SUBJECT: **R.E. Ginna Nuclear Power Plant**
Docket No. 50-244

License Amendment Request: Spent Fuel Pool Storage Capacity

Proposed Technical Specification Changes (Mark-up)

Figure 3.7.13-7
Burnup Vs Enrichment Curves for Region 2 Type 2 and Type 4 Cells (No Pu-241 Decay)

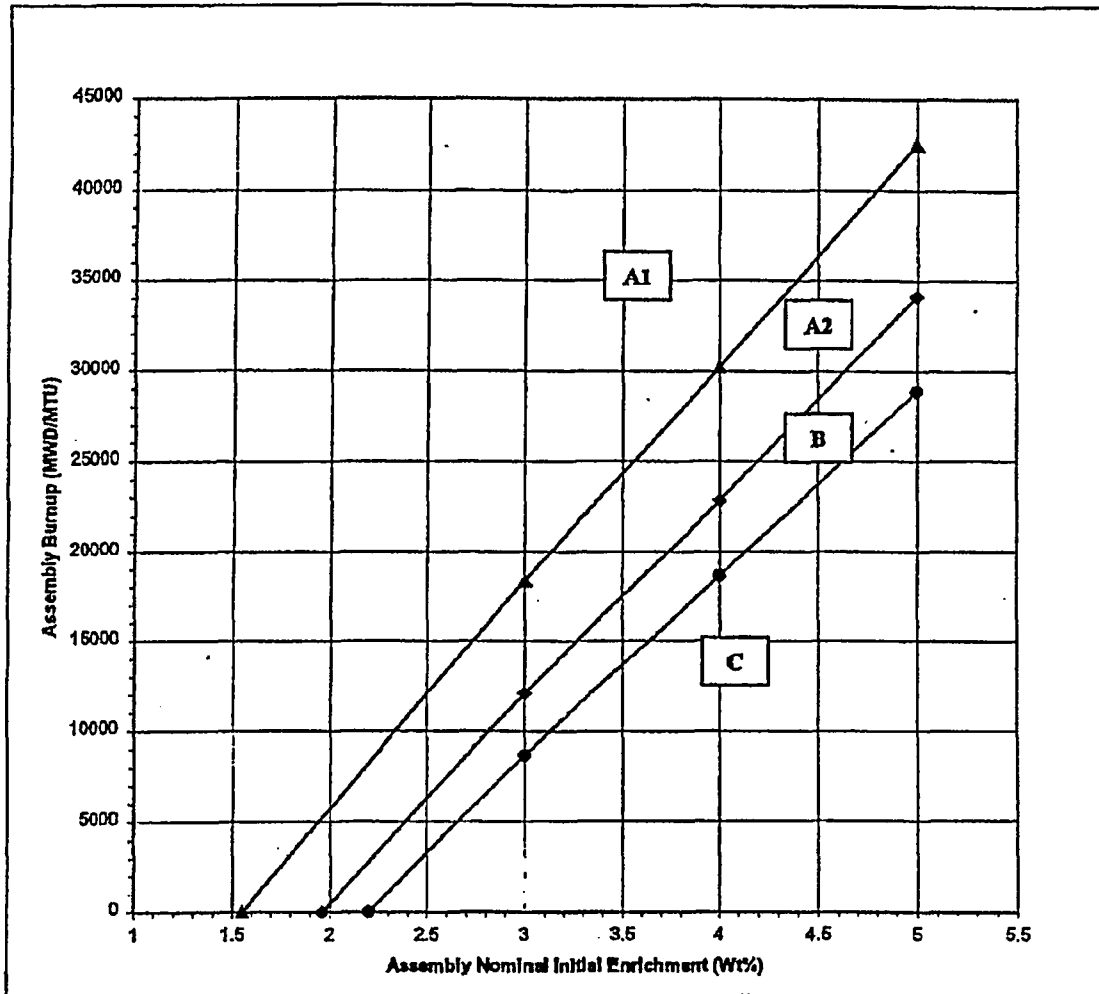
The specification for 1369 storage locations is based on allowing Ginna to install the additional wall mounted Type 4 module racks at a later time. Ginna no longer believes that installing these additional wall mounted racks is a storage option that will be implemented. Therefore, the maximum number of fuel assemblies that would be stored in the existing Ginna SFP after EPU will be limited to the 1321 existing storage locations and the reference to Type 4 racks will be removed.

- A1** Acceptable burnup domain for storage in any location within Region 2 Type 2 ~~and Type 4~~ Cells
- A2** Acceptable burnup domain for storage face-adjacent to a Type A1 or A2 assembly, or a water cell within Region 2 Type 2 ~~and Type 4~~ Cells
- B** Acceptable burnup domain for storage face-adjacent to a Type A1 assembly, or a water cell within Region 2 Type 2 ~~and Type 4~~ Cells
- C** Acceptable burnup domain for storage face-adjacent to a water cell only, within Region 2 Type 2 ~~and Type 4~~ Cells

Figure 3.7.13-9
Burnup Vs Enrichment Curves for Region 2 Type 2 and Type 4 Cells (10-Year Pu-241 Decay)

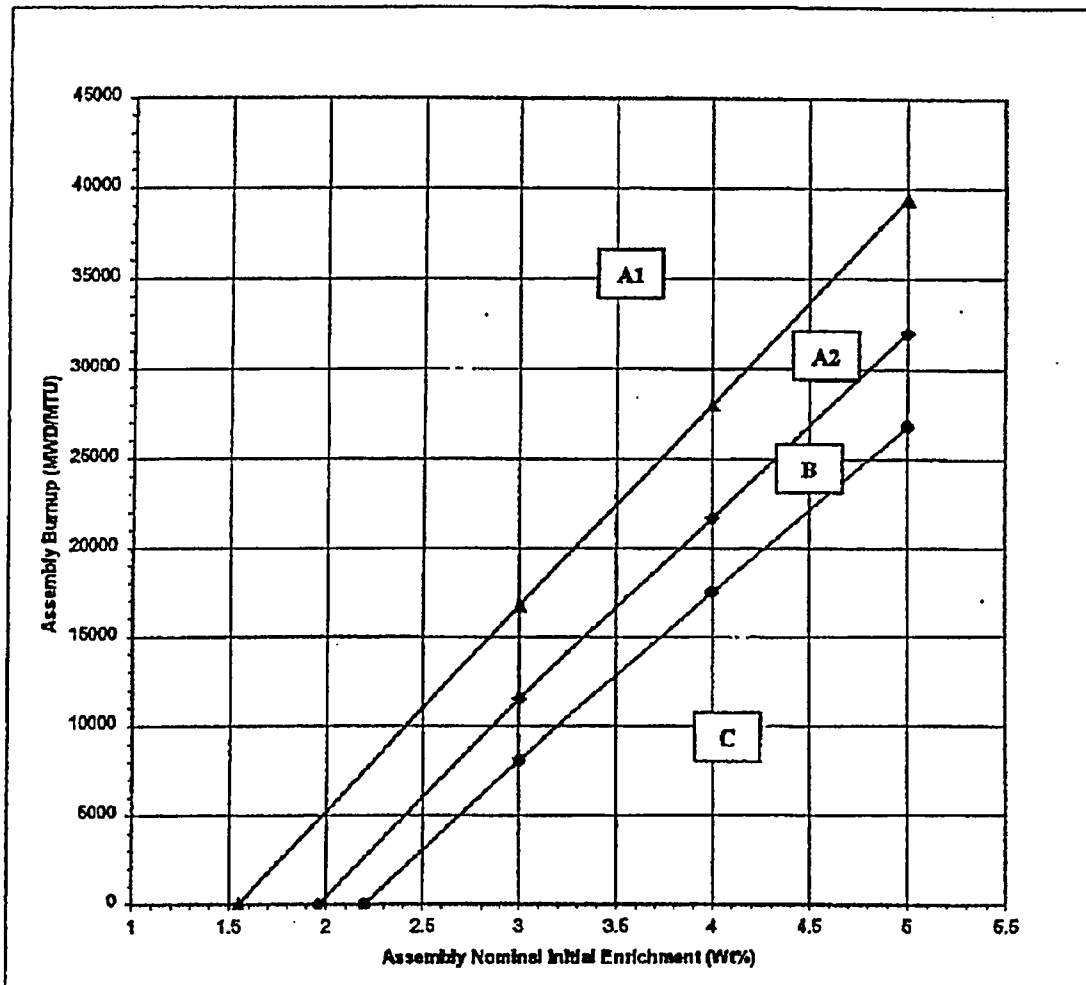
- A1 Acceptable burnup domain for storage in any location within Region 2 Type 2 ~~and Type 4~~ Cells
- A2 Acceptable burnup domain for storage face-adjacent to a Type A1 or A2 assembly, or a water cell within Region 2 Type 2 ~~and Type 4~~ Cells
- B Acceptable burnup domain for storage face-adjacent to a Type A1 assembly, or a water cell within Region 2 Type 2 ~~and Type 4~~ Cells
- C Acceptable burnup domain for storage face-adjacent to a water cell only, within Region 2 Type 2 ~~and Type 4~~ Cells

Figure 3.7.13-10
Burnup Vs Enrichment Curves for Region 2 Type 2 ~~and Type 4~~ Cells (15-Year Pu-241 Decay)

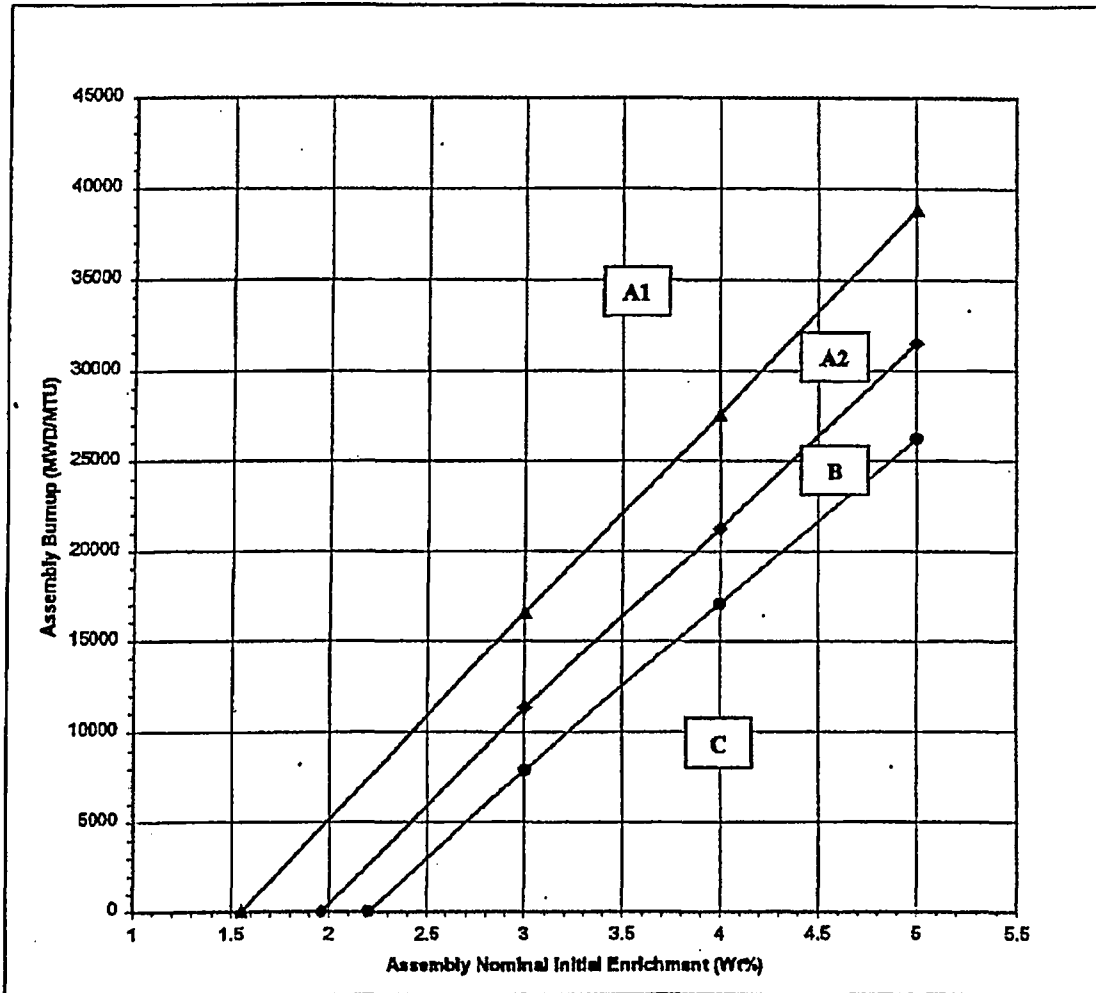
- A1 Acceptable burnup domain for storage in any location within Region 2 Type 2 ~~and Type 4~~ Cells
- A2 Acceptable burnup domain for storage face-adjacent to a Type A1 or A2 assembly, or a water cell within Region 2 Type 2 ~~and Type 4~~ Cells
- B Acceptable burnup domain for storage face-adjacent to a Type A1 assembly, or a water cell within Region 2 Type 2 ~~and Type 4~~ Cells
- C Acceptable burnup domain for storage face-adjacent to a water cell only, within Region 2 Type 2 ~~and Type 4~~ Cells
